2019 ROADWAY IMPROVEMENT PROJECT  
NEIGHBORHOOD ROADS  
SALEM, NH

**ADDENDUM No. 1**

**January 18, 2019**

# Precast Reinforced Catch Basin (Infiltration Basin)

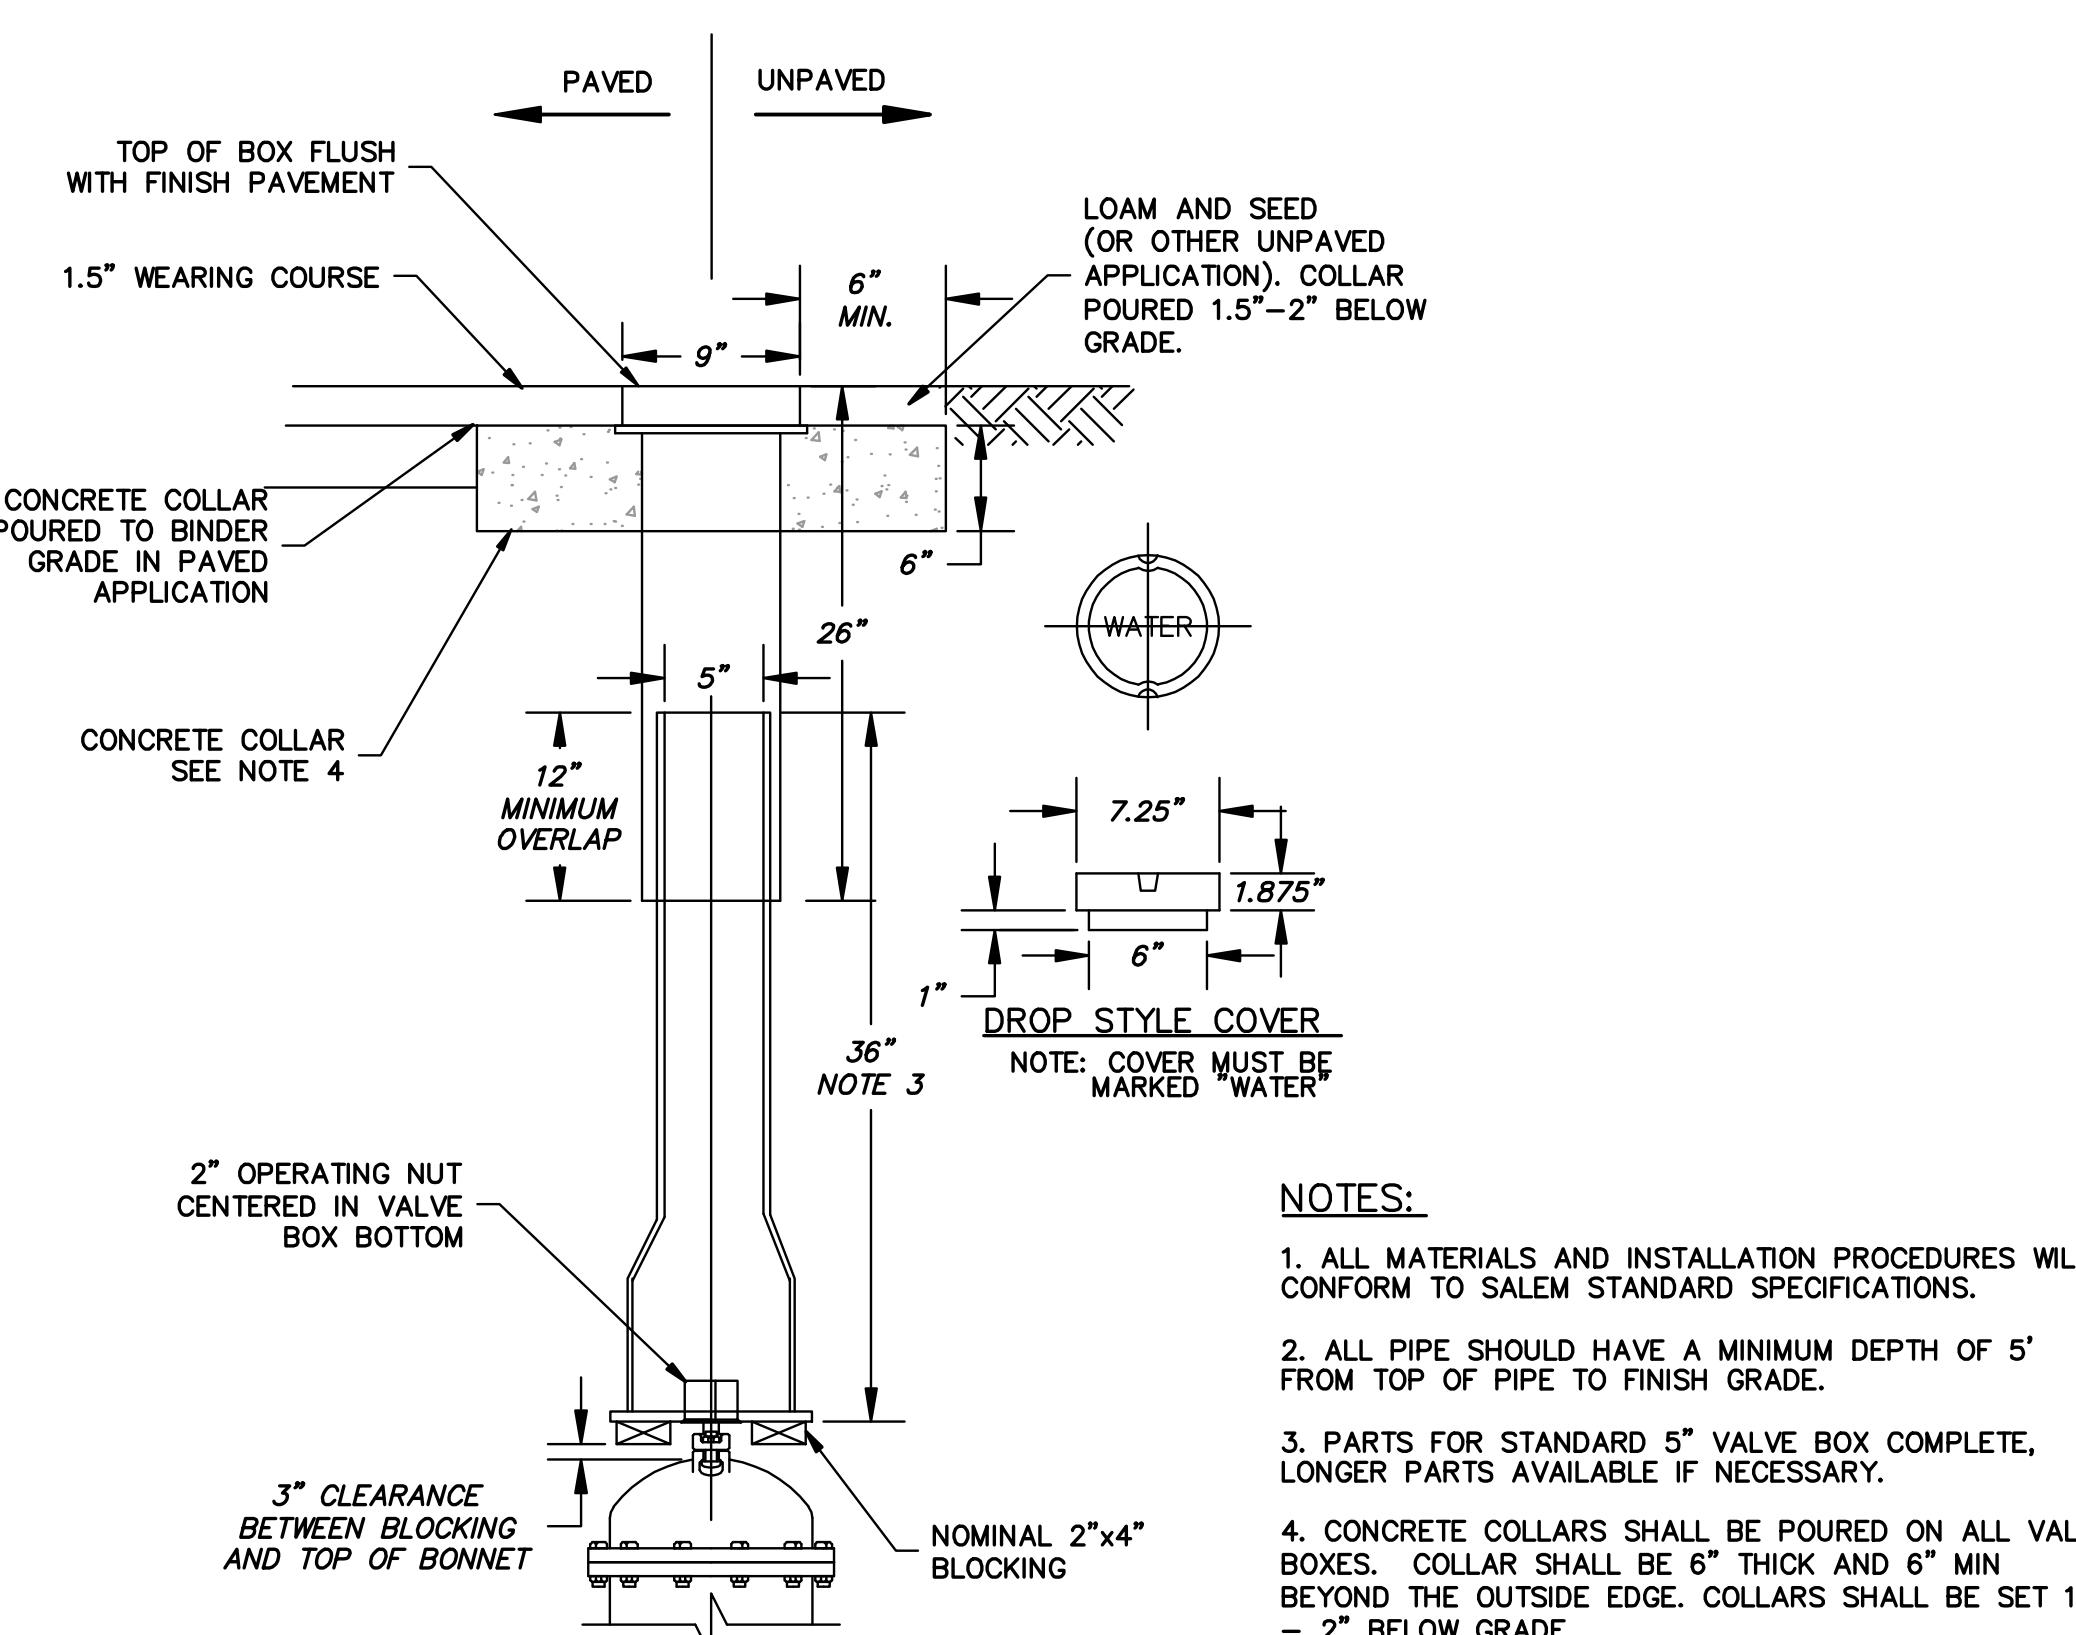
2. **Insert** the attached Drawing D4 – Details in the CONTRACT DOCUMENTS AND SPECIFICATIONS and **Discard** the original version of Drawing D4.

**The revised document provides a detail for Infiltration Catch Basins.**
